RIVERSIDE ENGINEERING CO. INC.
 RIVERSIDE, CALIFORNIA
 APPROVED *George O. Crawley* R.E. 9455 DATE 12-5-58
CITY OF RIVERSIDE, CALIFORNIA
 DEPARTMENT OF PUBLIC WORKS
 VICTORIA HILLS UNIT 1 & 2
 ELSINORE ROAD
 SEWER PLAN & PROFILE
 1" = 50' HORIZ -SCALE- VERT 1" = 5'
 APPROVED BY *[Signature]*
 Director of Public Works
 DATE Dec 22, 1958 SHEET 1 of 4

SEWER PLAN & PROFILE
TELEFAIR WAY & BENBOW PL.

SEWER PLAN & PROFILE
 IN EASEMENT FROM
 FAIRVIEW AVE TO BENBOW PL

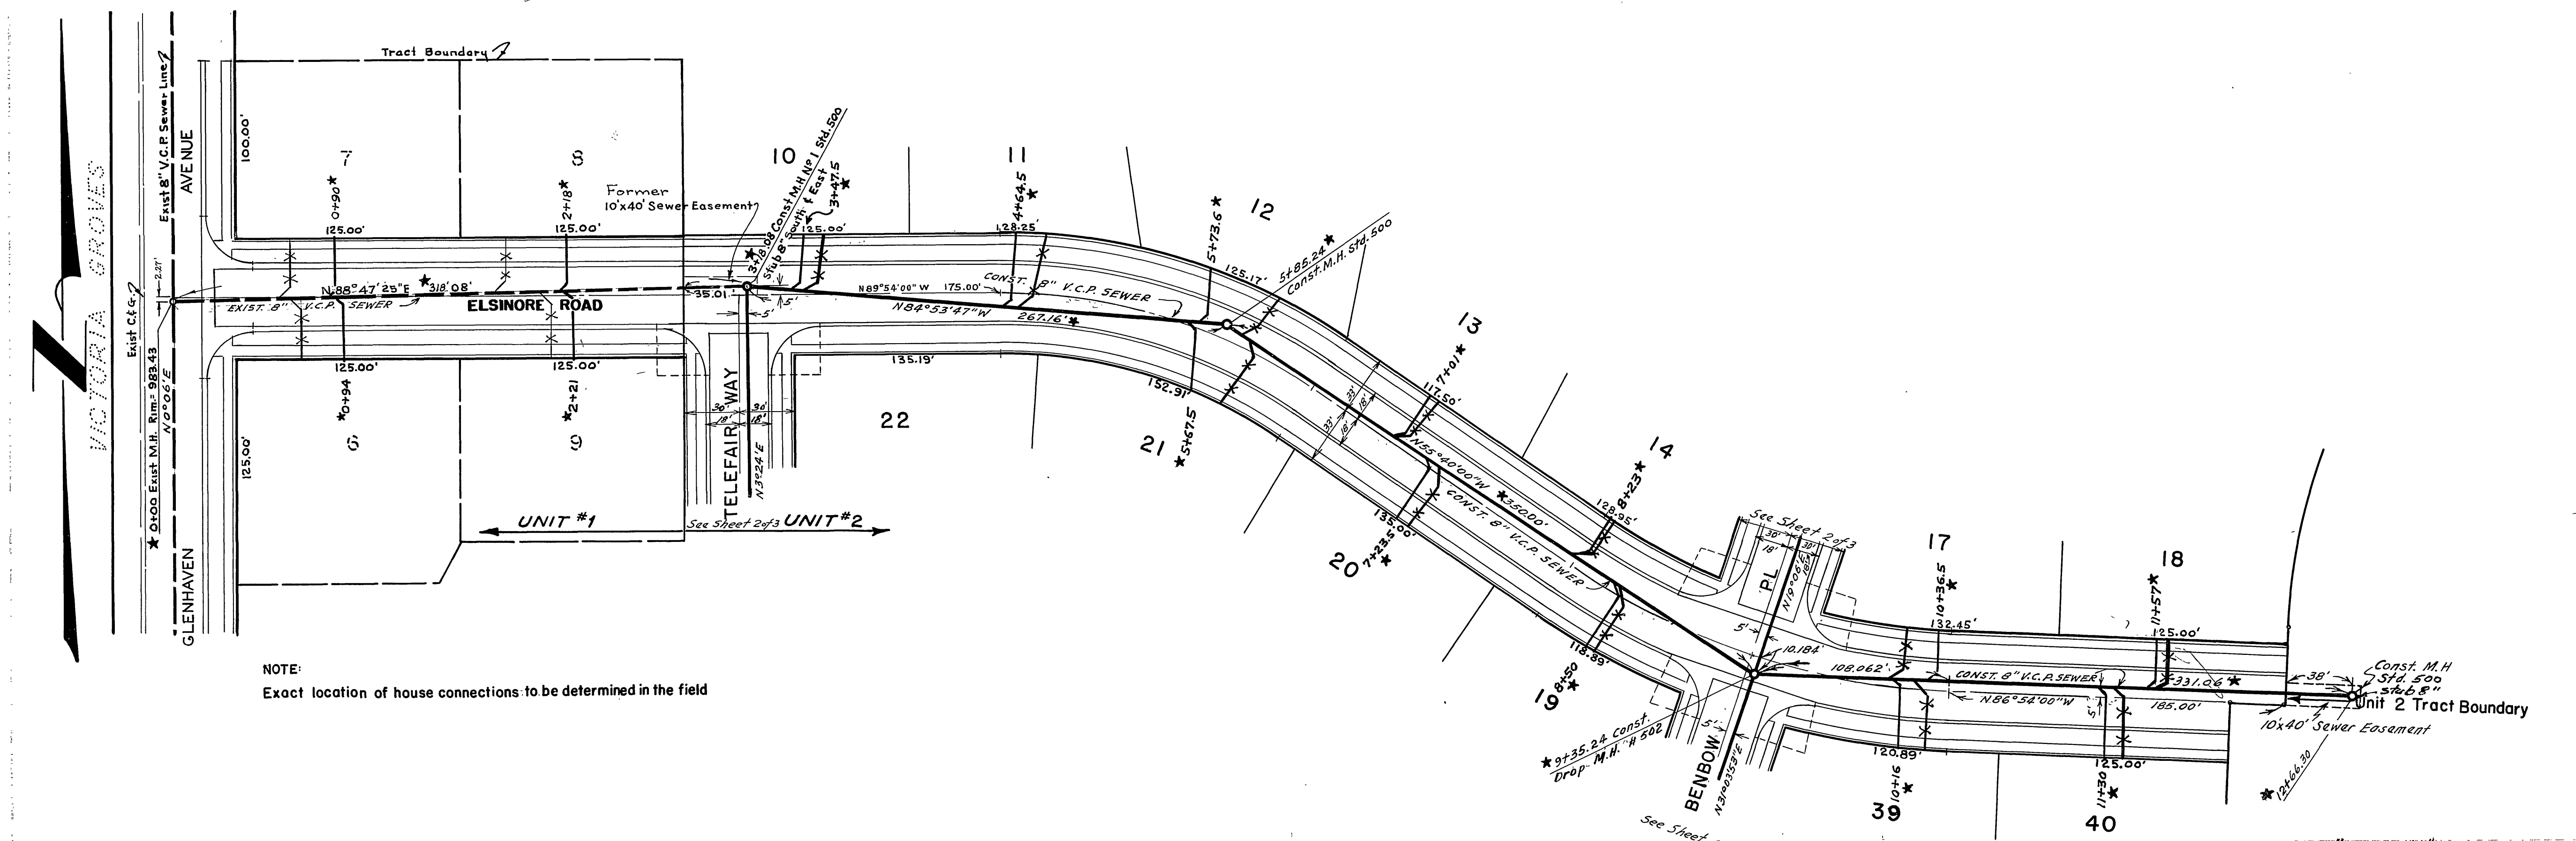
NOTE:
 THIS PLAN HAS BEEN REVISED BY ADDING ELSINORE ROAD FROM STA. 2+83.00 TO STA. 12+23.66 (UNIT TWO) AND BY CHANGING THE GRADE BETWEEN STA. 1+50.00 & STA. 2+183.00 ON 6-10-59 - PLAN RENUMBERED FROM 1 OF 2 TO 1 OF 4

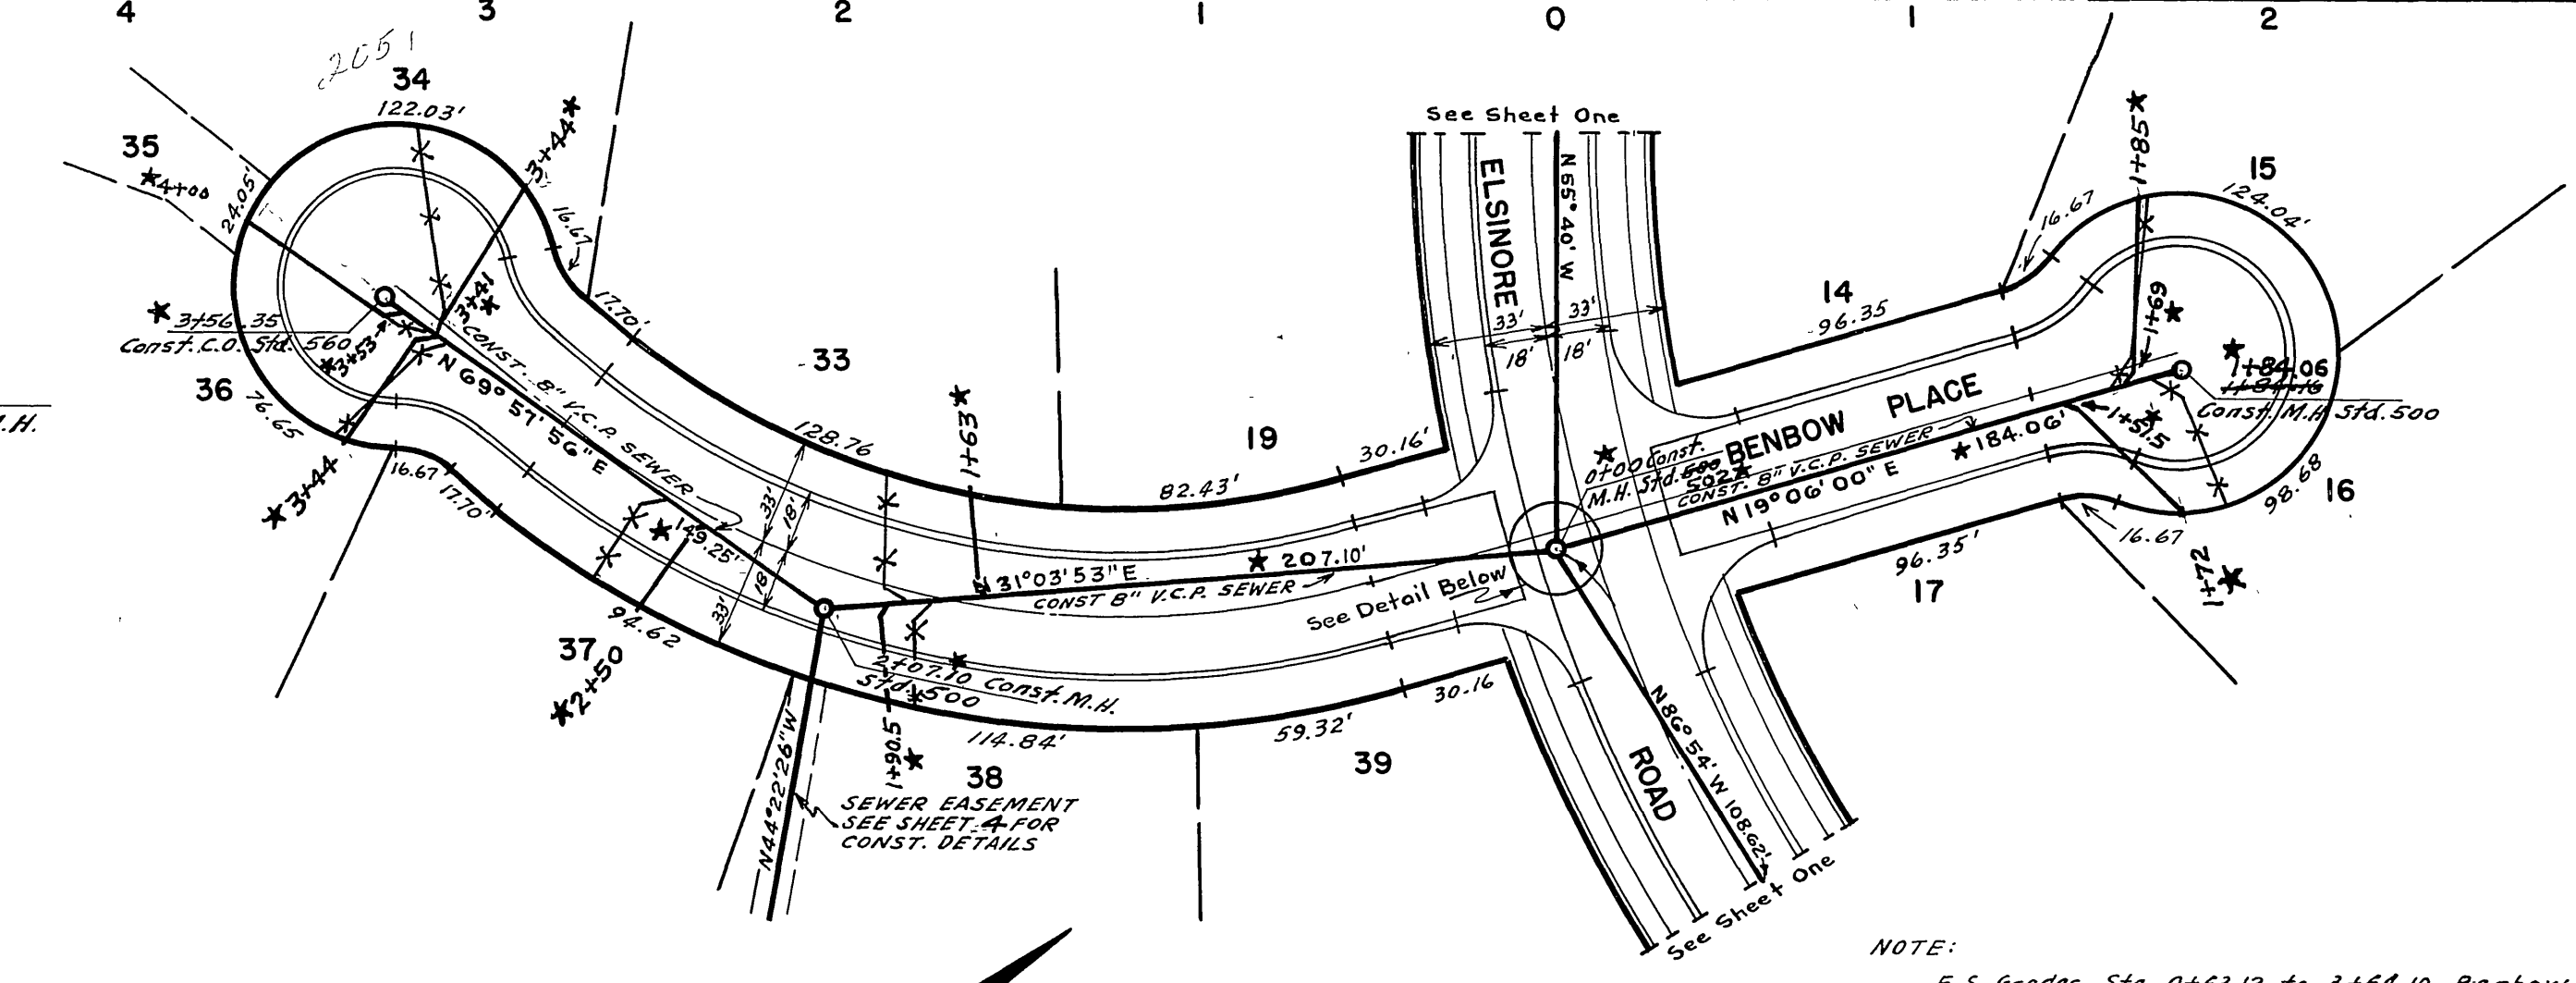
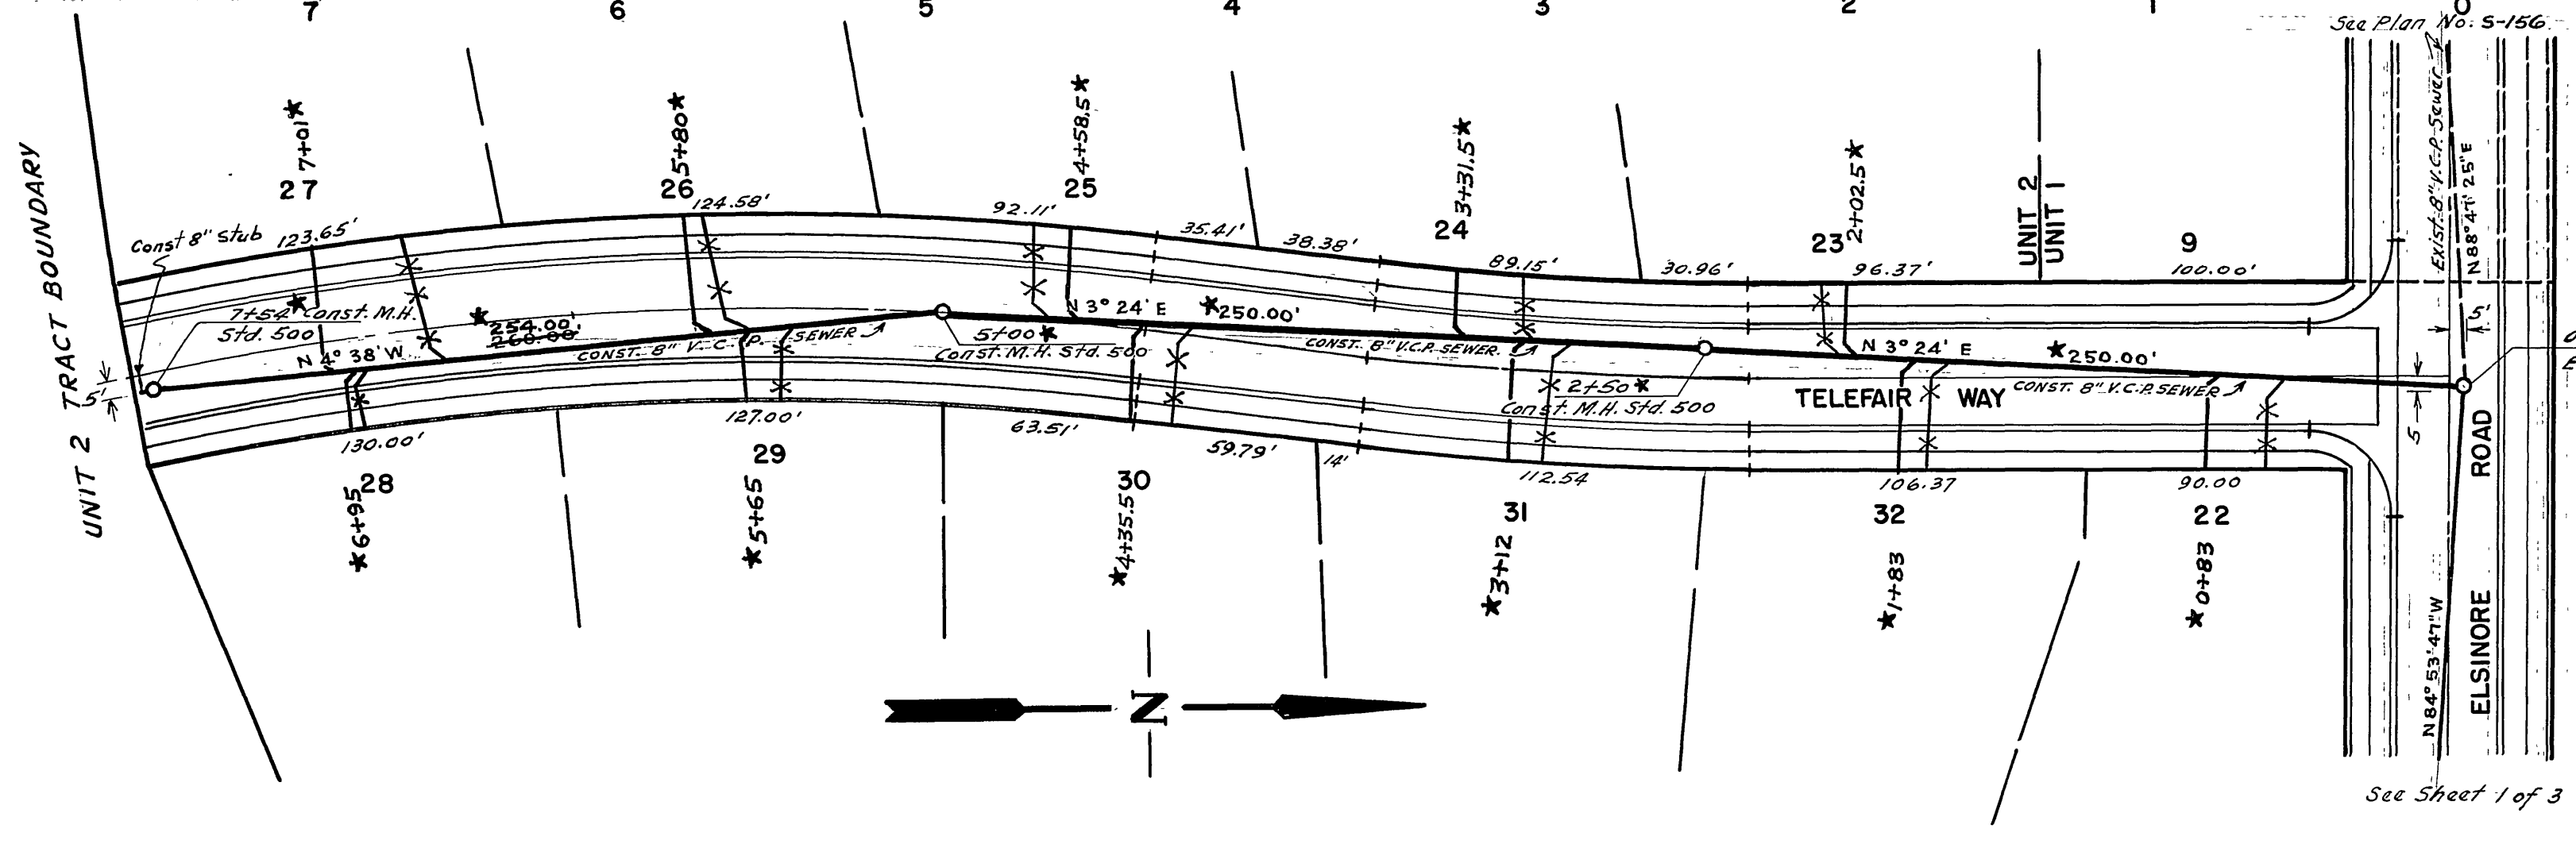
NOTE:
F.S. Grades Sta. 0+83.12 to 3+64.10 Benbow Place
Revised October 7, 1959.
